A RESOLUTION AUTHORIZING THE MAYOR AND CITY CLERK TO APPROVE A CHANGE ORDER WITH MILESTONE CONSTRUCTION FOR WATER AND SEWER IMPROVEMENTS RELATED TO THE RAZORBACK GREENWAY REALIGNMENT PROJECT

Section 1. The Mayor and City Clerk are authorized to execute Change Order #1 to the Razorback Greenway Realignment Project for a change order of \$326,716.00 for water and sewer upgrades.

Subject: COR #001 Razorback Greenway Realignment

EMMA AVENUE WATER & SEWER UTILITY RELOCATIONS

W.2
Page 11

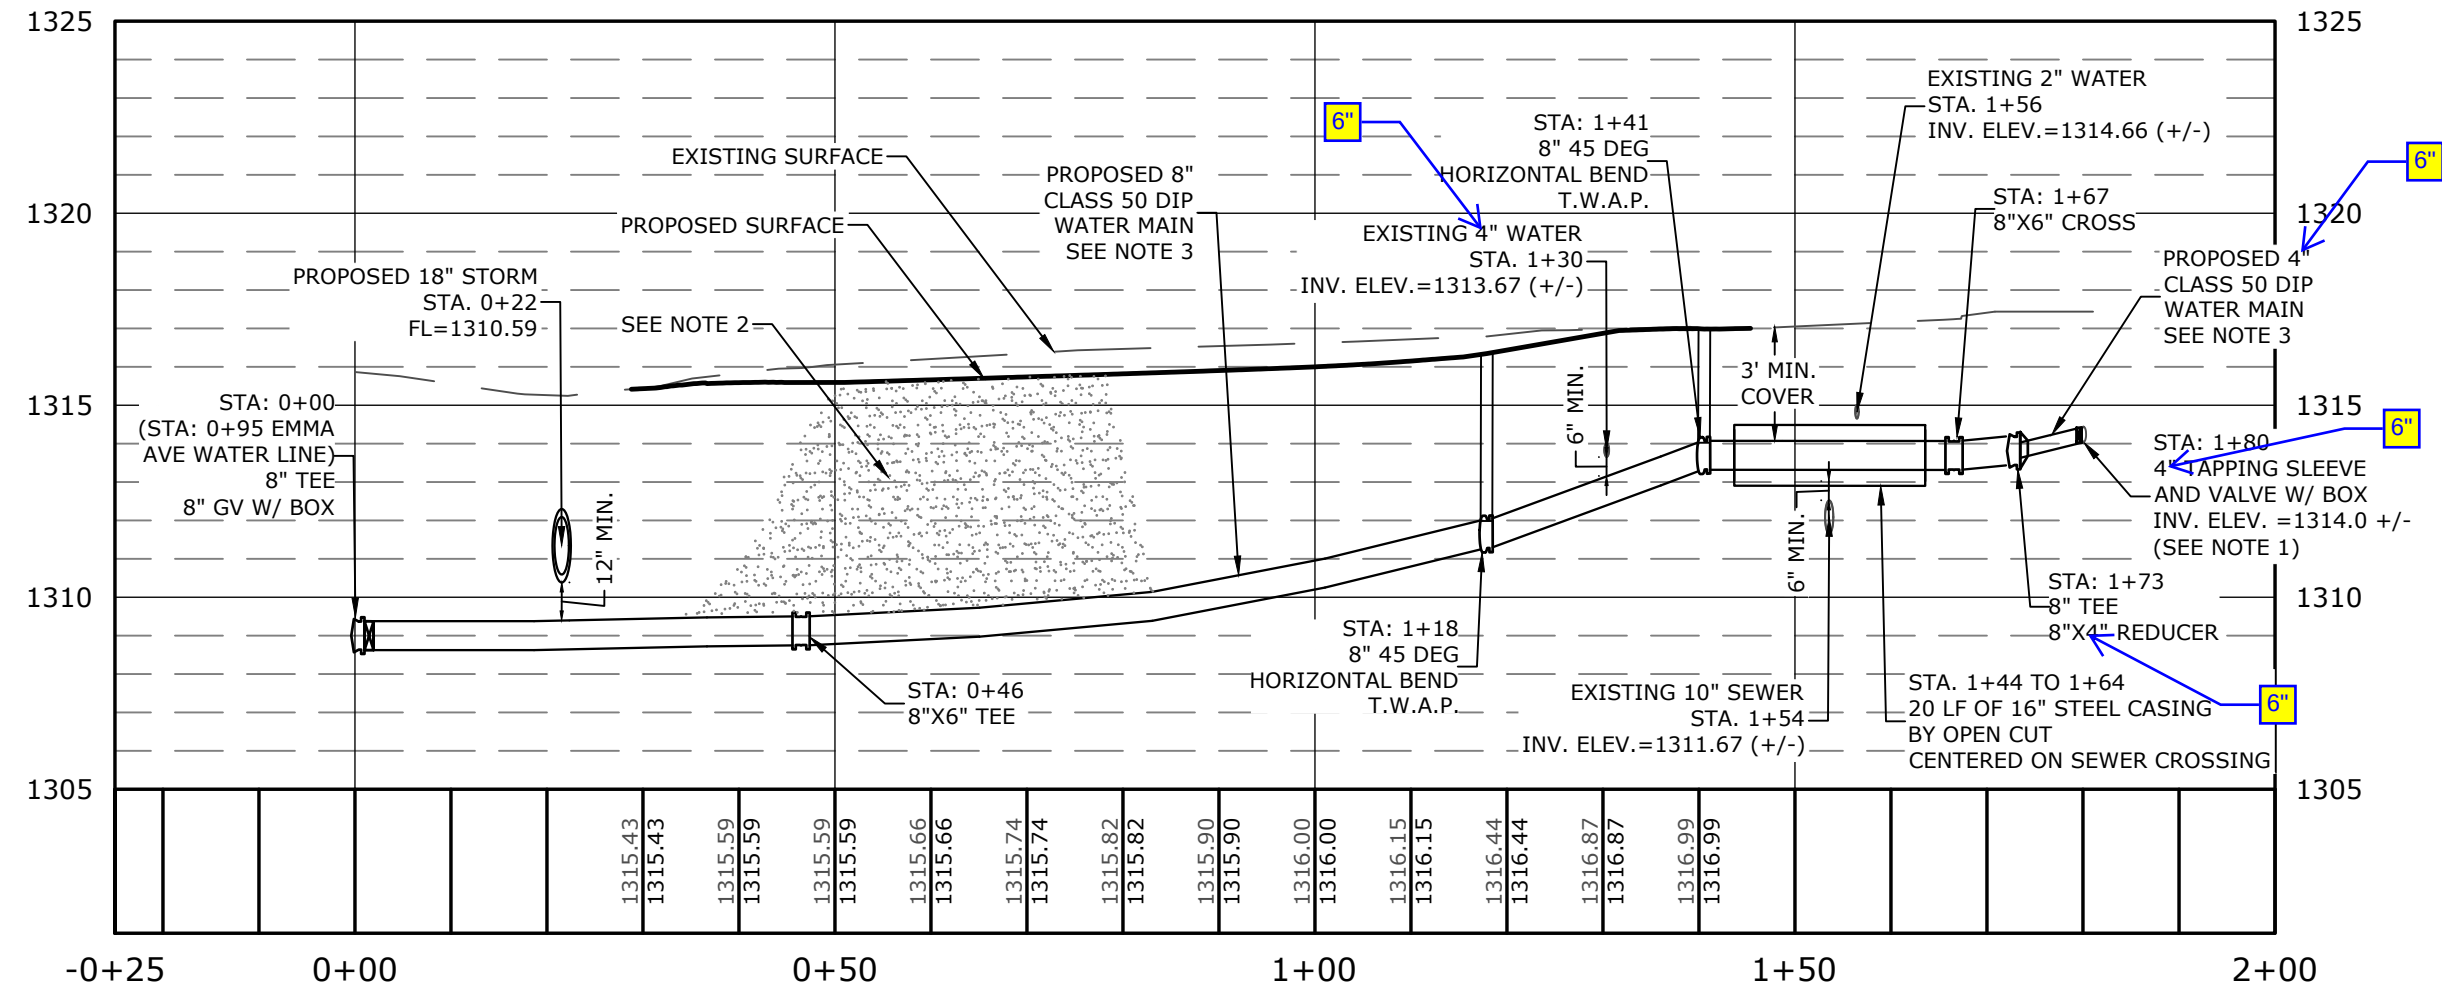
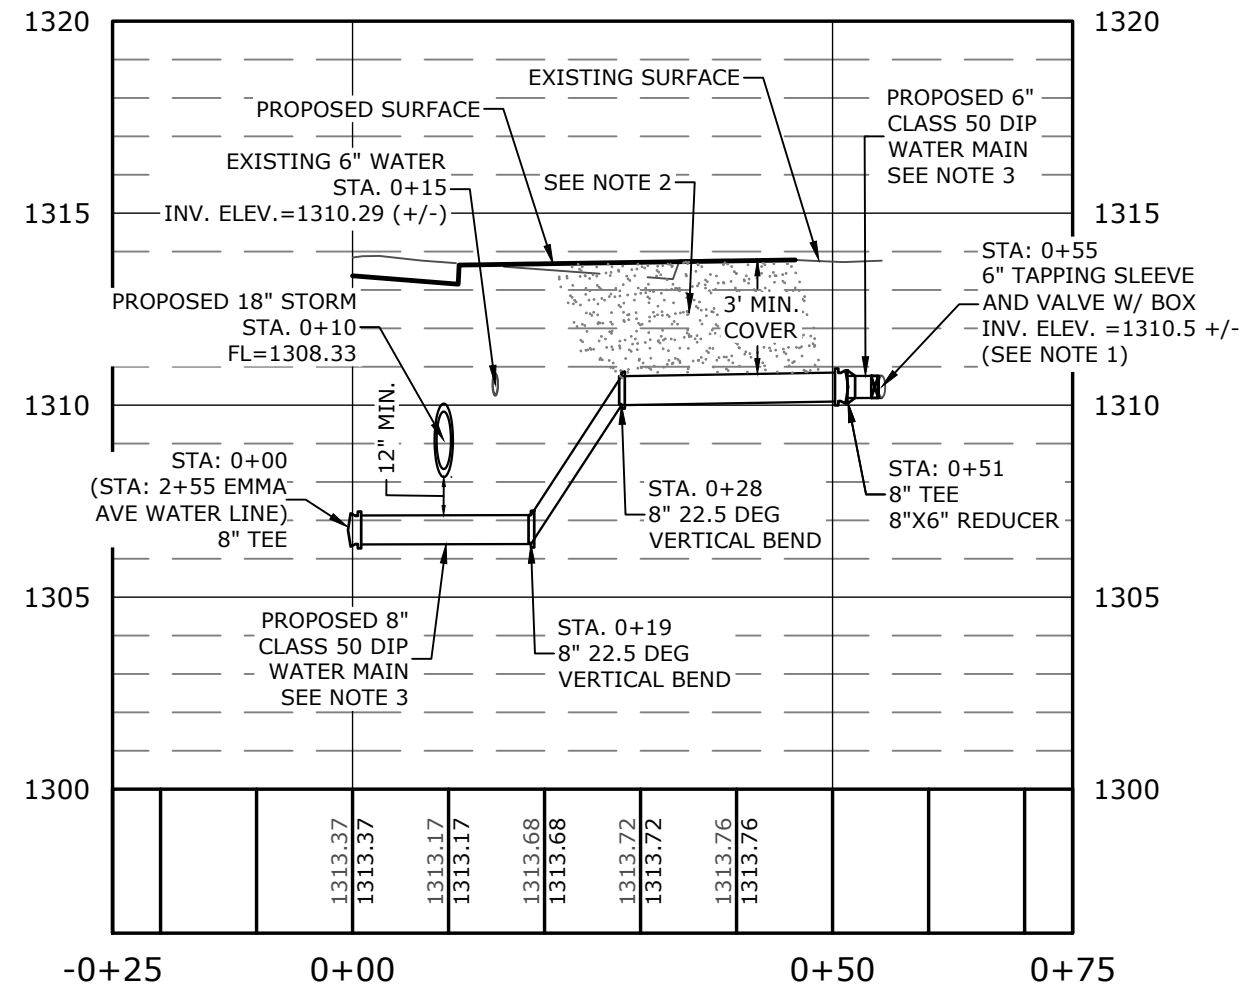
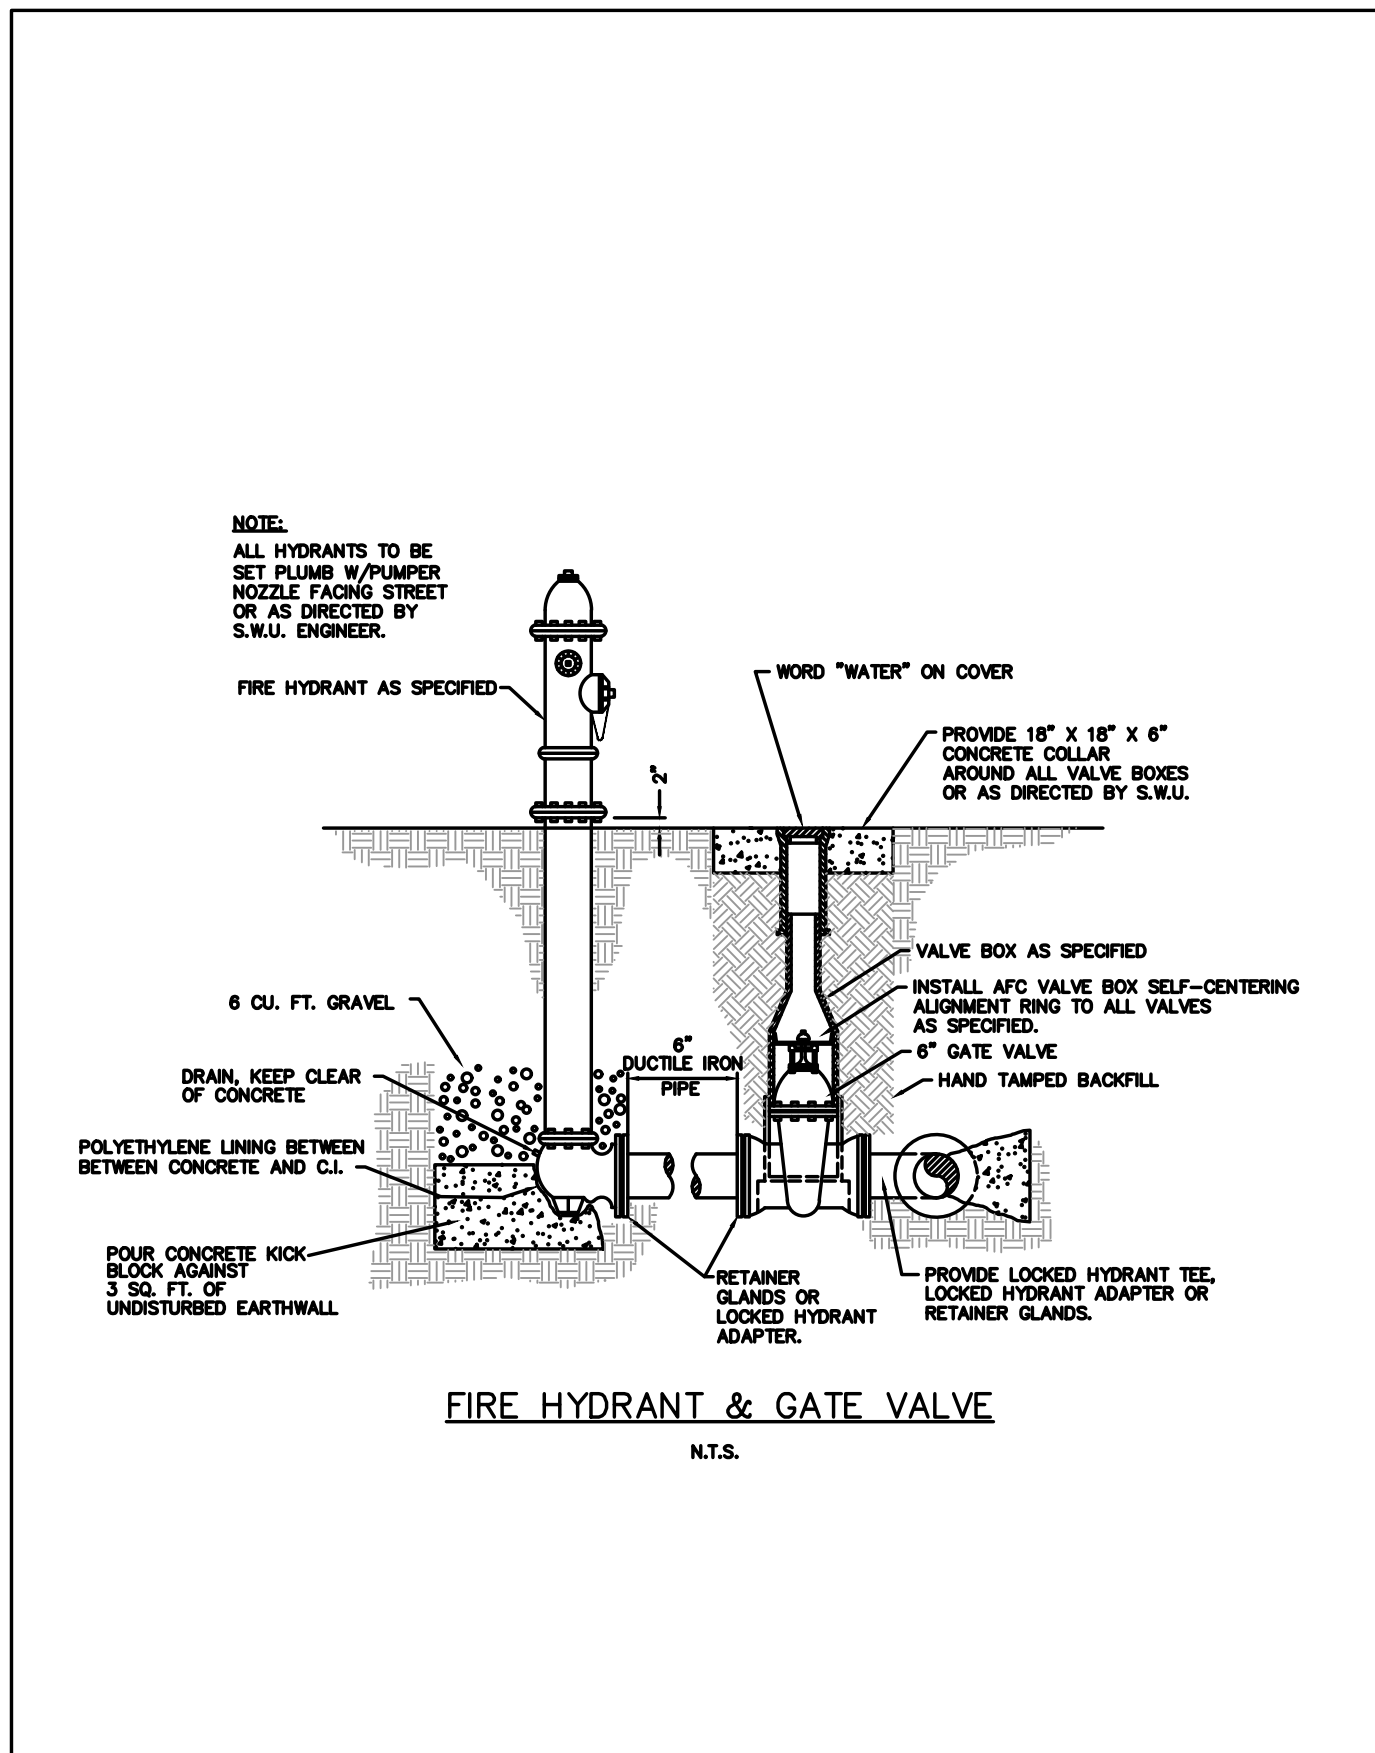
- a. Water – Provide and install water line as shown on the drawings on pages W1 & W2. Piping to be C900 DR-14. Price includes joint restraints, thrust blocks and steel encasement with guides. Includes valves, hydrants, and fittings as necessary to avoid existing utilities as shown.
- b. Includes removal and replacement of asphalt as shown on the drawings W1 & W2, including the removal of concrete in areas of asphalt removal as shown and down Holcomb Street as necessary to install new water line and cut and cap. Includes repair of asphalt as shown on W1 & W2 drawings.
